Madera South High School – HVAC Improvement
Madera Unified School District

Date: 01/29/2025
NET POSITIVE Project No.: 1337
Client Project No.: **Base Bid 1**
DSA File No.: 20-H3
DSA Appl. No.: 02-122086

The following additions, deletions and revisions to the plans, specifications and Addenda shall become a part of the plans and specifications. It is the responsibility of the General Contractor to submit the information contained in this addendum to all subcontractors and suppliers. The Bidder shall acknowledge receipt of the Addendum in the Bid Proposal. (Addendum number of pages: **4** pages + **21** drawings + **0** attachments = **25** total pages).

MECHANICAL DETAILS

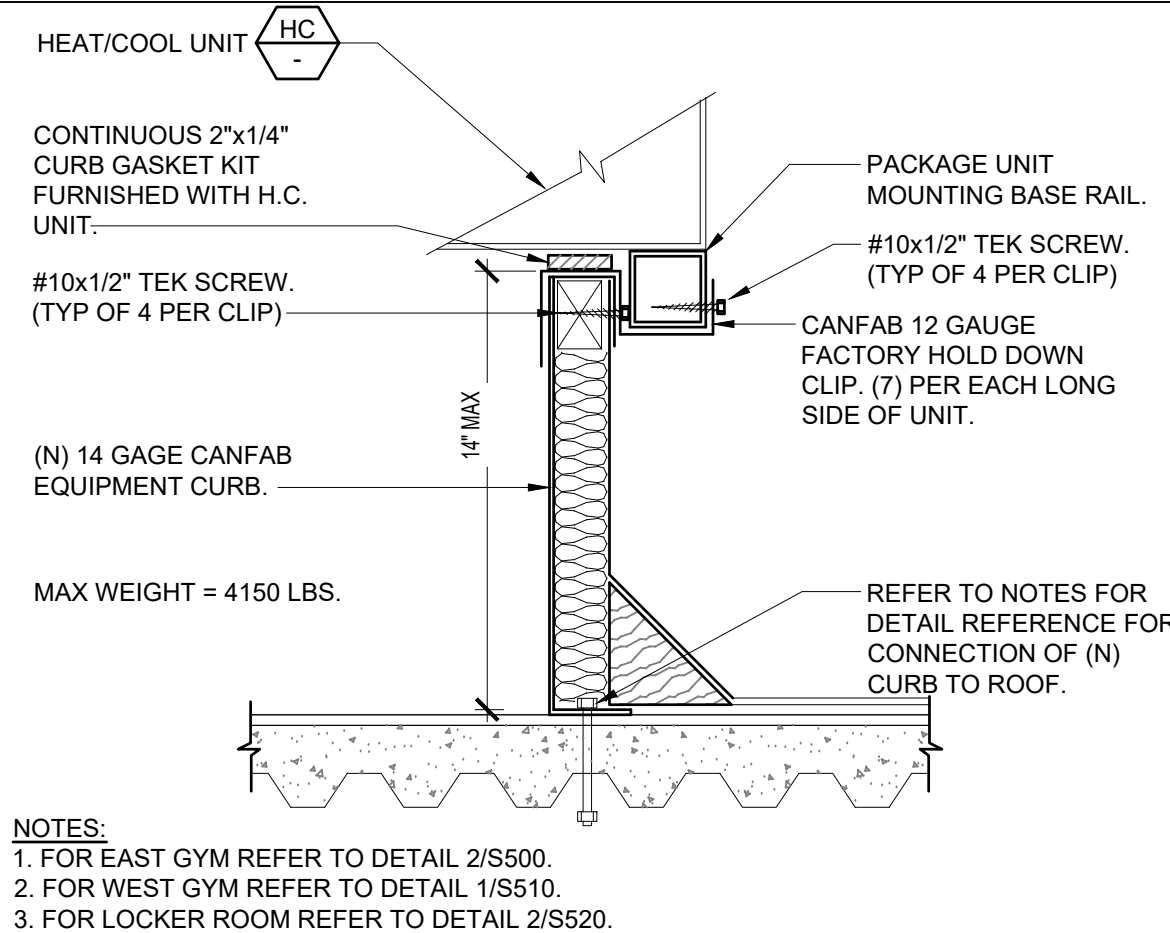
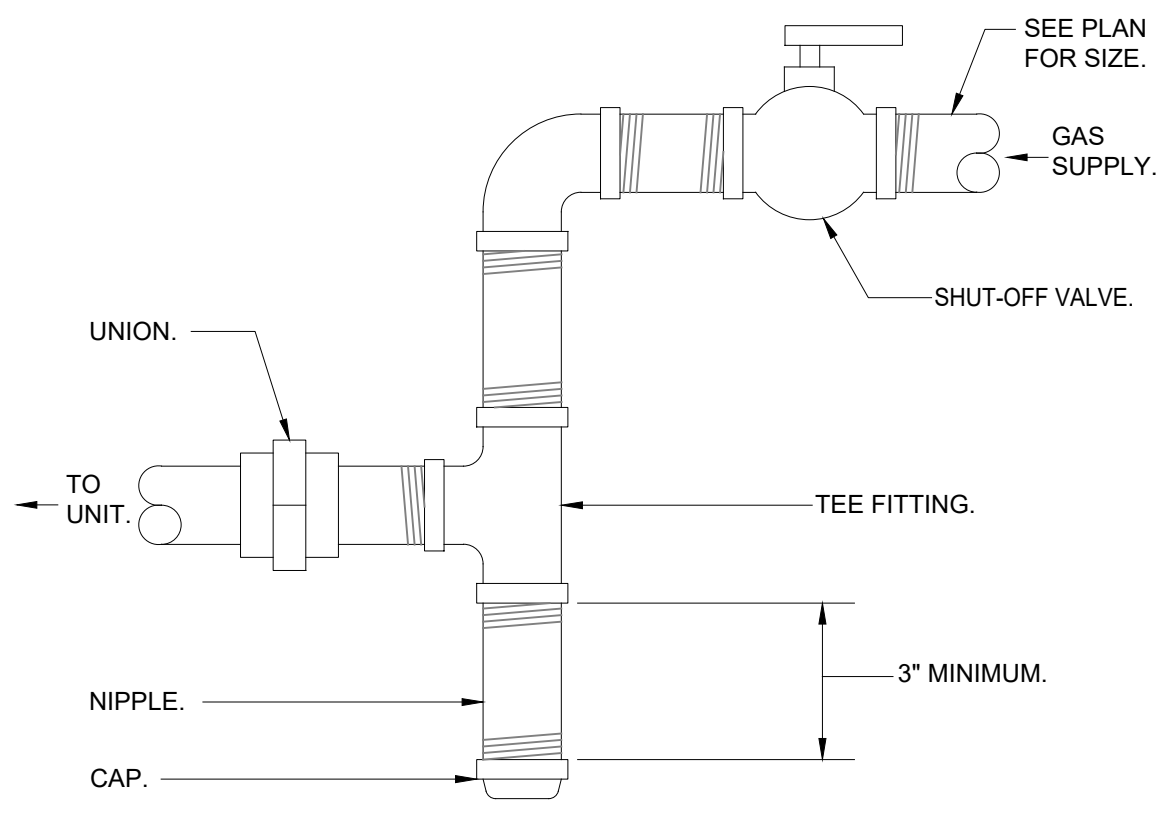
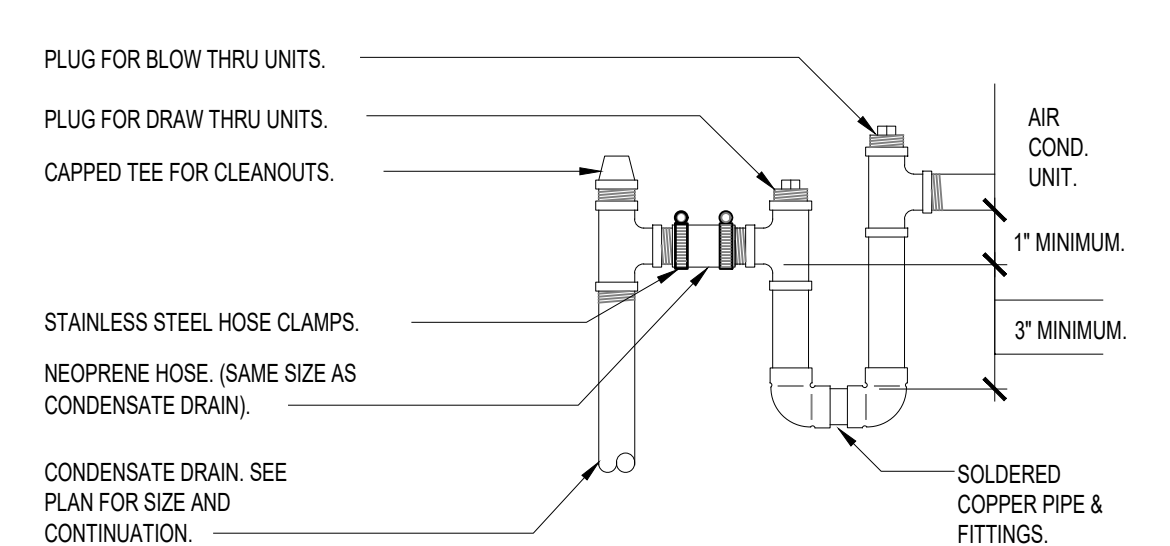
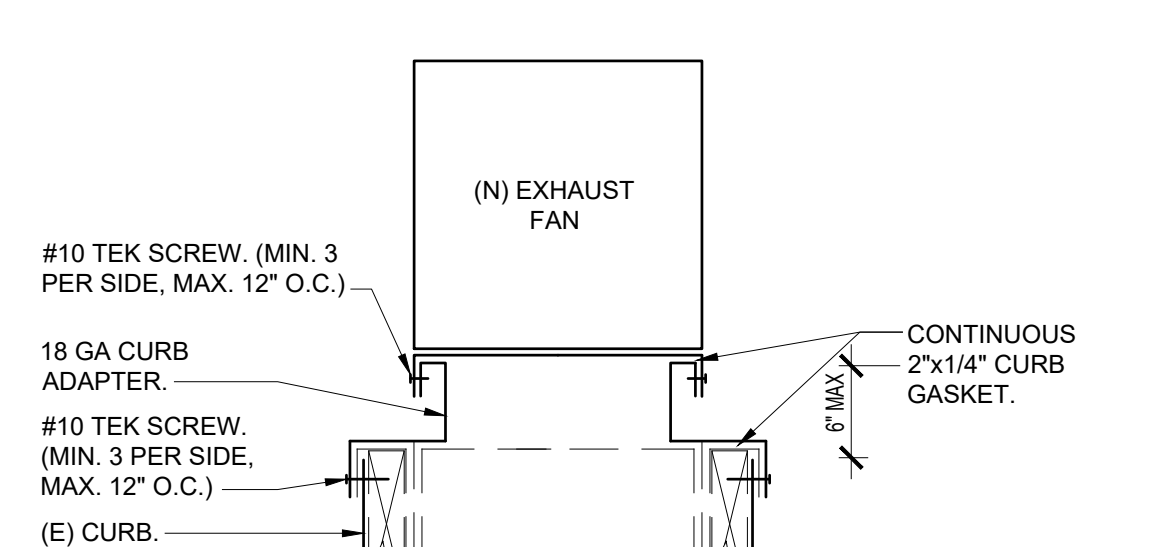
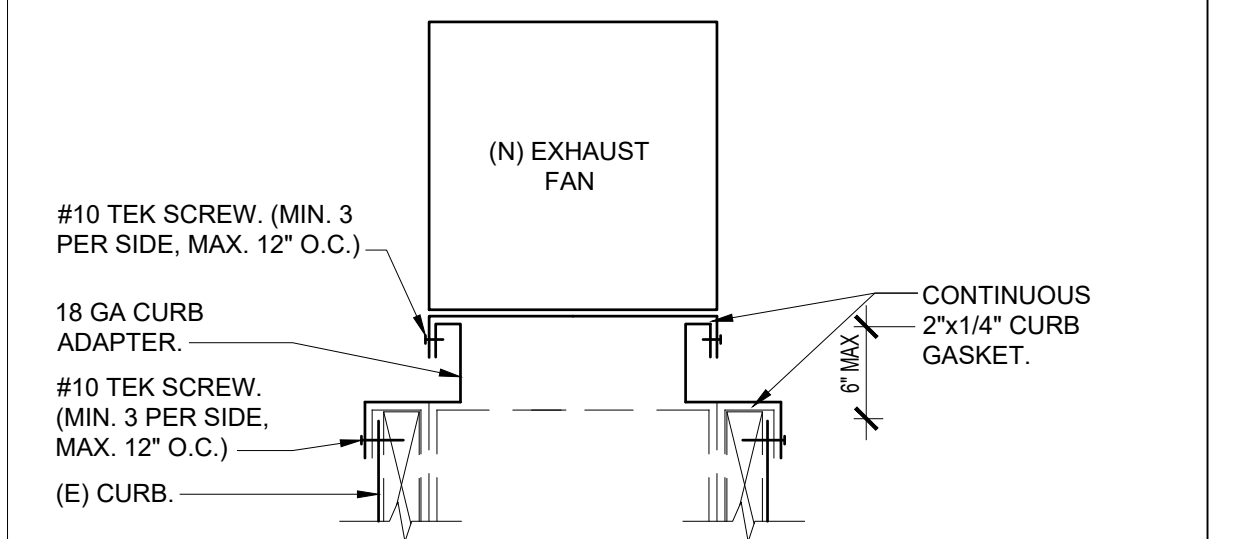
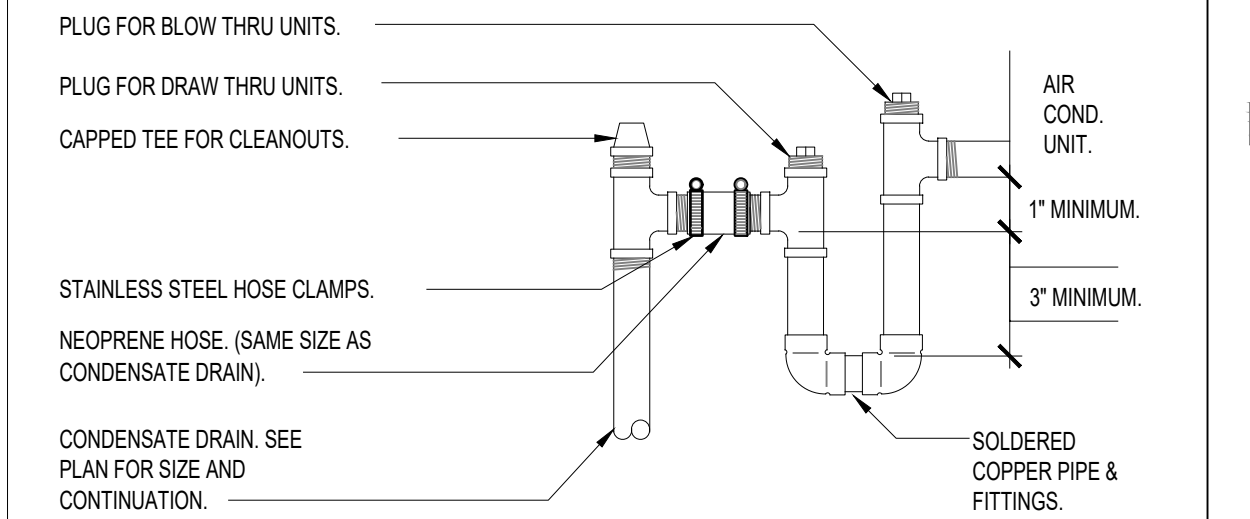
01-08: DRAWINGS, SHEET M800 – MECHANICAL DETAILS, revise as follows:

- A. Remove Drawing Sheet No. M800 in its entirety and replace with Addenda Drawing No. M800 AD01-08.
 - a. Revise Detail 1 and Detail 4.
 - b. Removed Details 5, 6, 7, and 9.
